UNITED STATES PATENT AND TRADEMARK OFFICE

APPLICATION NO.	FILING DATE	FIRST NAMED INVENTOR	ATTORNEY DOCKET NO.	CONFIRMATION NO.
10/802,260	03/16/2004	Frank J. Cunha	EH-11037A	4311

Office Action Summary

DETAILED ACTION

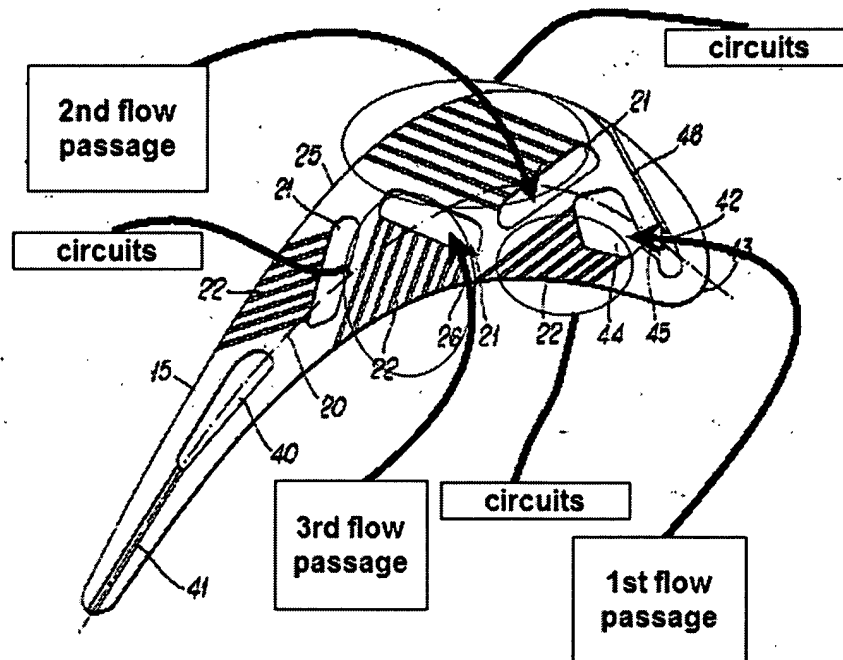
Moore teaches a turbine airfoil 15, comprising: pressure and suction sidewalls extending longitudinally in span from a root to a tip, and extending in chord between leading and trailing edges, said sidewalls being spaced laterally apart between said leading and trailing edges (see Figs. 1-3) wherein said airfoil defines a first flow passage 44 and a second flow passage 21, said first and second flow passages for flowing coolant fluid therethrough; a plurality of cooling circuits 22 embedded within said

pressure sidewall, wherein each of said cooling circuits includes: an inlet, said inlet provides a cooling flow path from said first flow passage into each of said cooling circuits, and an exit aperture, said exit aperture provides a cooling flow path out of each of said cooling circuits to a region outside of the airfoil; and a plurality of cooling circuits embedded within said suction sidewall, wherein each of said cooling circuits embedded within said suction sidewall includes: an inlet, said inlet provides a cooling flow path from said second flow passage into each of said cooling circuits embedded within said suction sidewall, and an exit aperture, said exit aperture provides a cooling flow path out of each of said cooling circuits embedded within said suction sidewall to said region outside the airfoil (see annotated Figure below taken from Moore); wherein said first flow passage is not in flow communication with said cooling circuits embedded within said suction sidewall and said second flow passage is not in flow communication with said cooling circuits embedded within said pressure sidewall such that said first flow passage feeds the coolant fluid to said cooling circuits that are embedded only within said pressure sidewall and said second flow passage feeds the coolant fluid to said cooling circuits that are embedded only within said suction sidewall .

Moore shows a third flow passage disposed downstream said second passage and upstream said trailing edge, said third flow passage for flowing coolant fluid therethrough; wherein said third flow passage is not in flow communication with said cooling circuits embedded within said suction sidewall such that said third flow passage feeds the coolant fluid to a portion of said cooling circuits that are embedded within said pressure sidewall (see annotated Figure above taken from Moore).
